RFI-025

Subject: BP3 Gold Walk Bearing Conditions
Project: Steamboat - BV BP Promenade and Goldwalk
Address: 2305 Mount Werner Circle
Steamboat Springs CO 80487 USA
Phone:
To: John Hart
Coggins & Sons, Inc.
From: Saunders Construction, LLC

Subject: Excavation Observations and
Recommendations, Steamboat Base Area
Redevelopment – Gold Walk, Steamboat
Springs, Colorado.

TYP SPREAD FOOTING

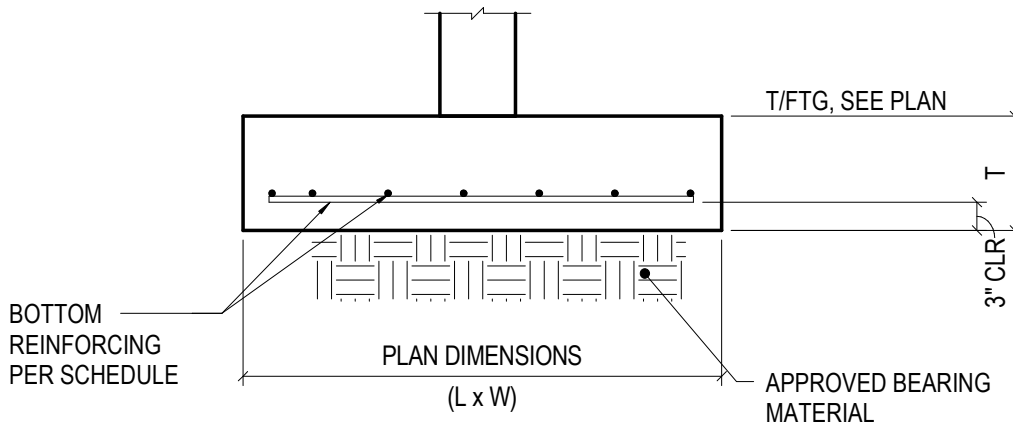
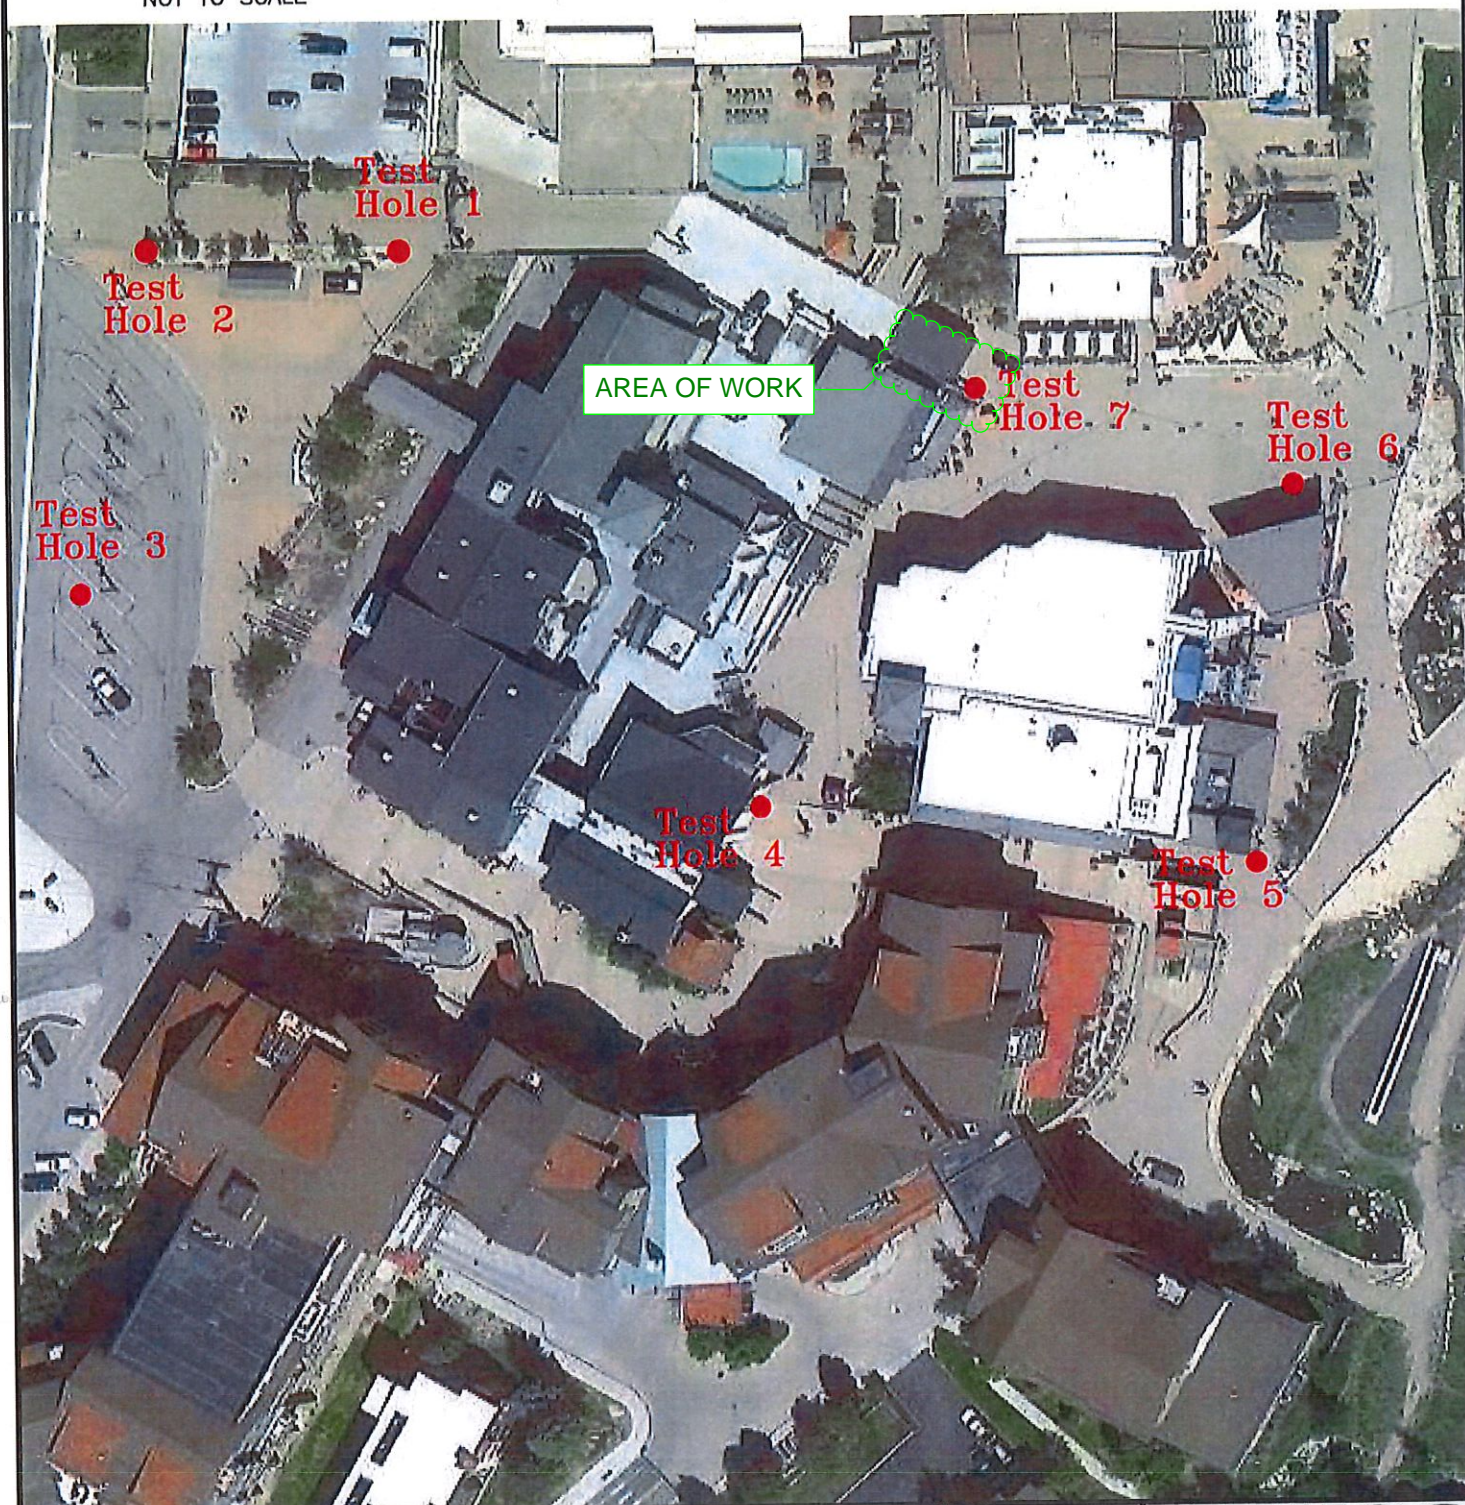
During open hole inspection following excavations for Gold Walk footers, NWCC had communicated that soils in area were composed of old building fill and that 3,000PSF would not be achievable with current subsurface conditions. Please see attached soils report with reference to location of work.

SPREAD FOOTING SCHEDULE				
SOIL ALLOWABLE PRESSURE = 3000 PSF				
MARK	FOOTING SIZE L x W x T	REINFORCING	SERVICE CAPACITY (KIPS)	REMARKS
F6x6	6'-0"x6'-0"x1'-4"	(7) #5 EW BOT	108	-

SEE ATTACHED OBSERVATIONS AND RECOMMENDATIONS
SEE ATTACHED EMAIL DIRECTION FROM SCI TO PROCEED WITH MICROPILE DESIGN
SEE ATTACHED MARTIN/MARTIN LOAD CALCULATIONS
SUBMIT MICROPILE DESIGN AS DEFERRED SUBMITTAL
JAPPLE, GENSLER, 6/28/2021

Footing recommendations included in the S&FI report should be observed with the following additional recommendations for flow fill. Based on the amount of over excavation which would be required if footings are opted for, we recommend backfilling the excavation with flow fill material to the proposed footing grade. Flow fill should have a minimum 28-day compressive strength of 200 psi and extend at least 5 feet beyond the edges of the footings. An allowable bearing capacity of 3,000 psf can be used for footings placed on flow fill materials placed on the natural sands and gravels.

Description
GOLDWALK - LEVEL 1 FRAMING PLAN

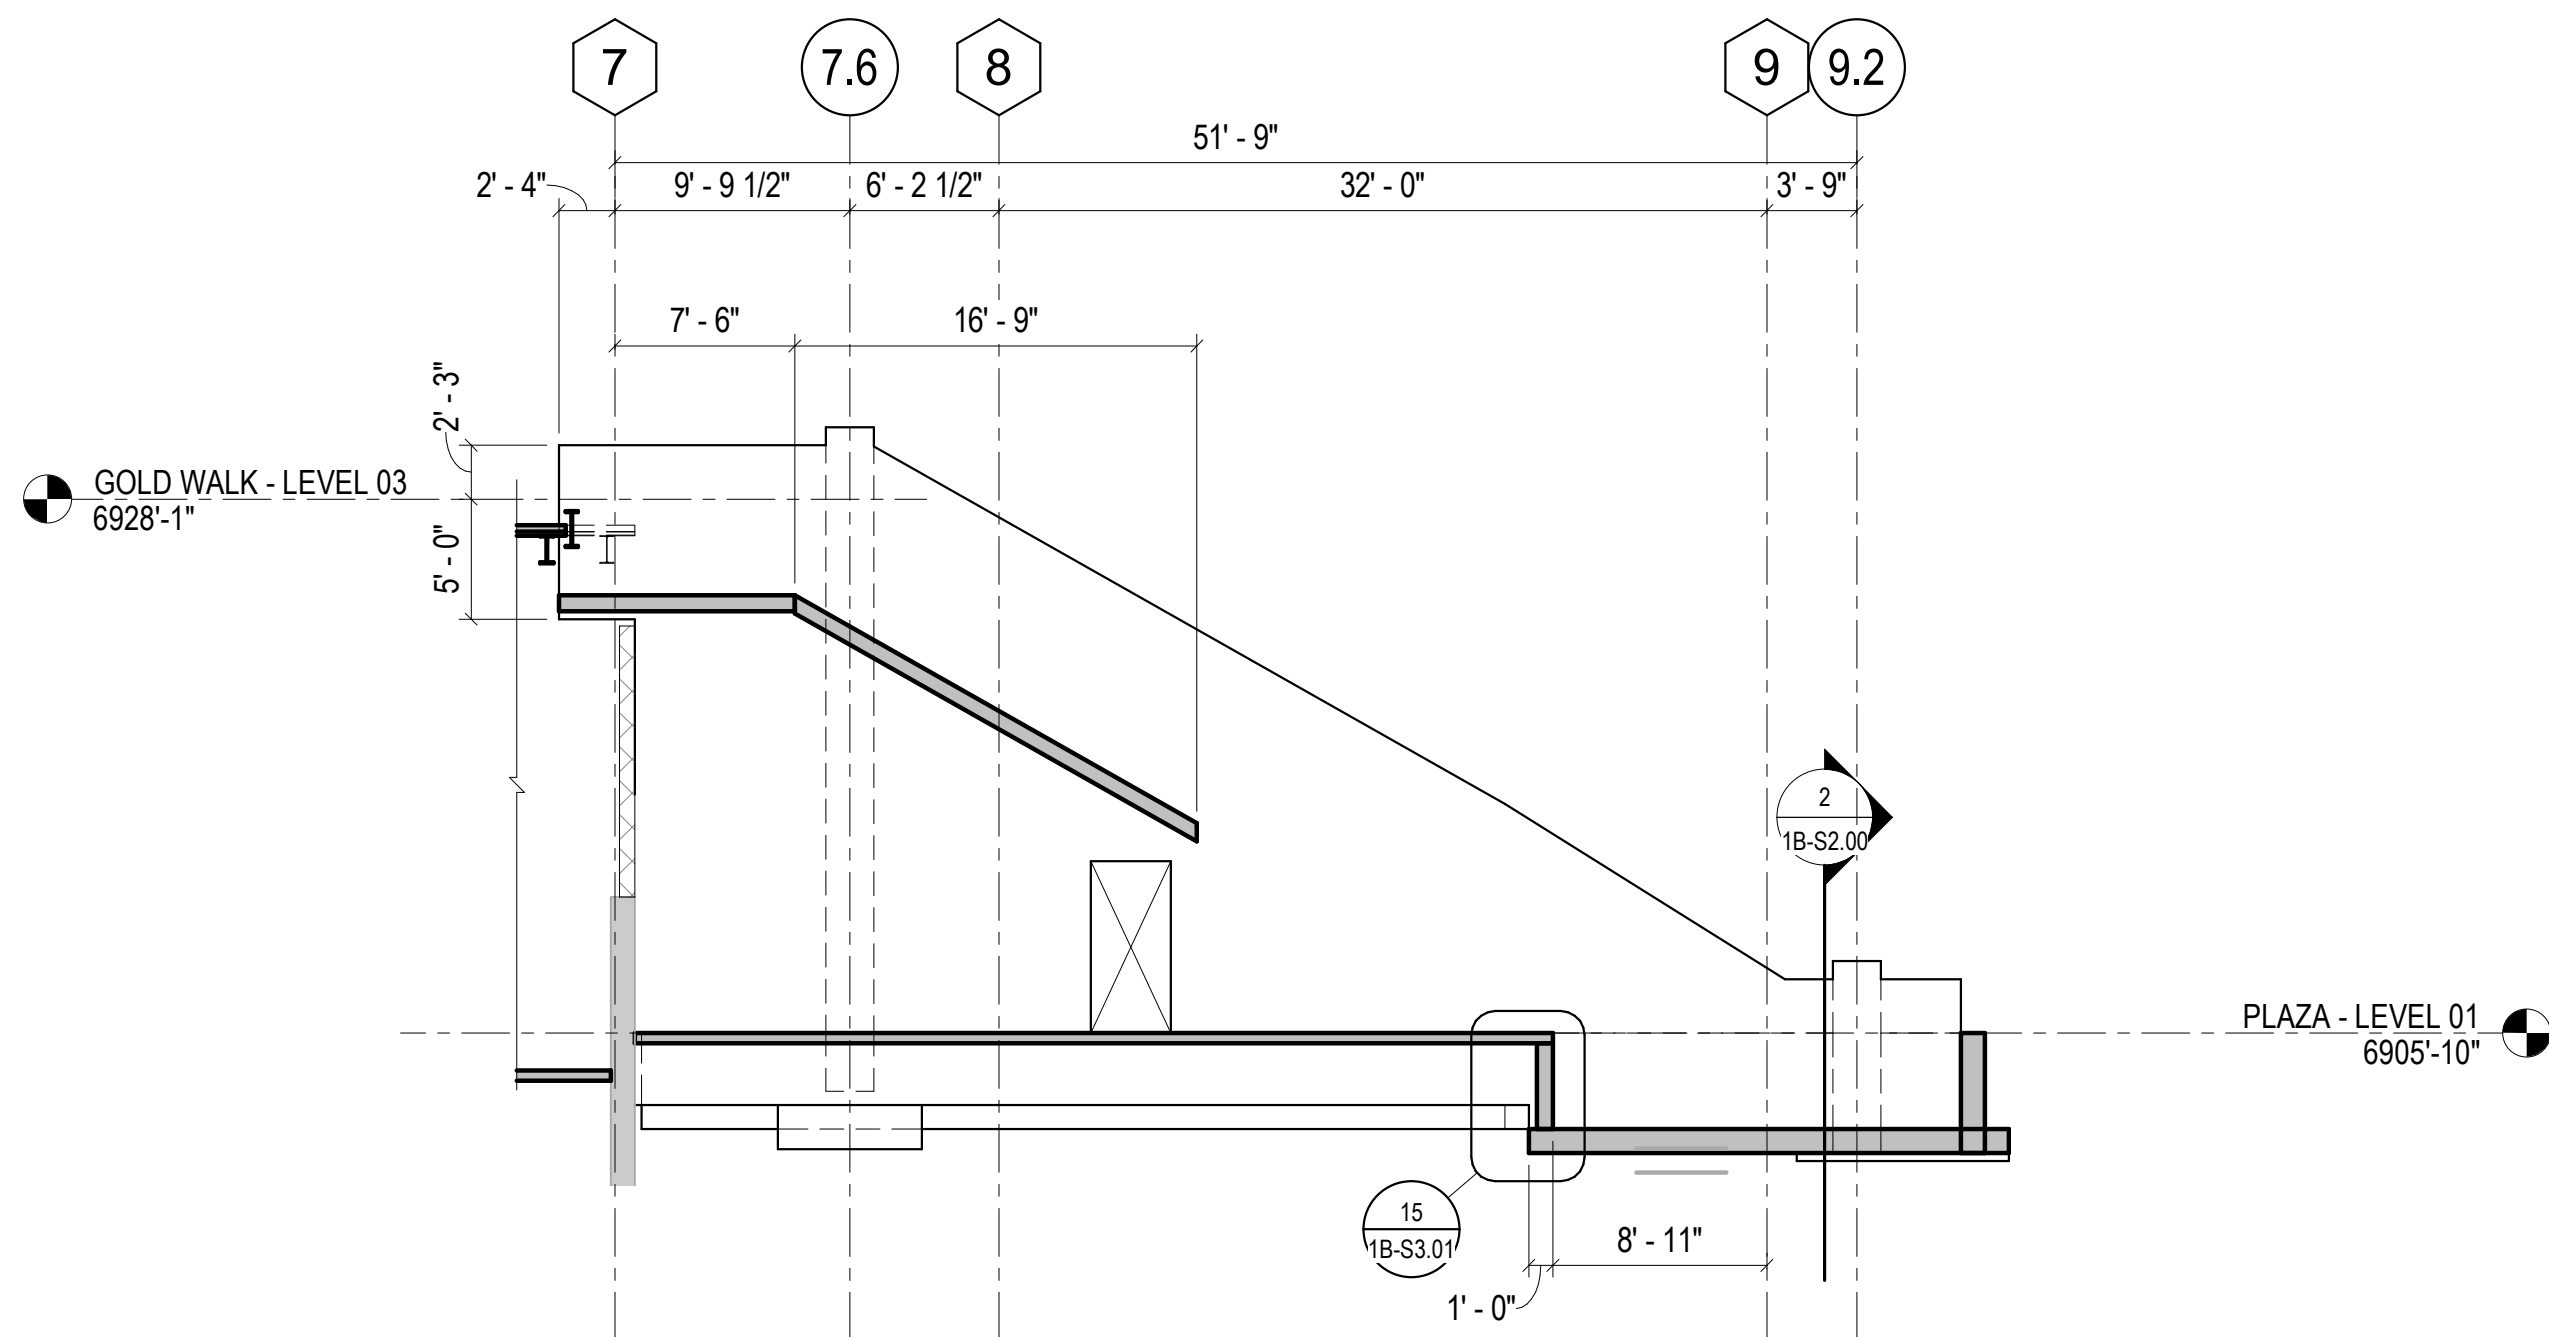
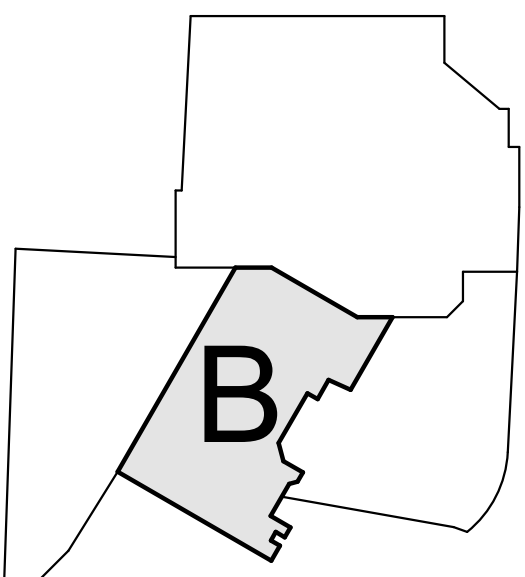
M/M Notes:
1. All loads are given in ASD load combination.
2. Please provide proposed micropile capacities and spacing requirements, M/M to revise walls and foundation elements to micropile design.
3. Please confirm with NWCC that the current soil condition is suitable for slab on grade.
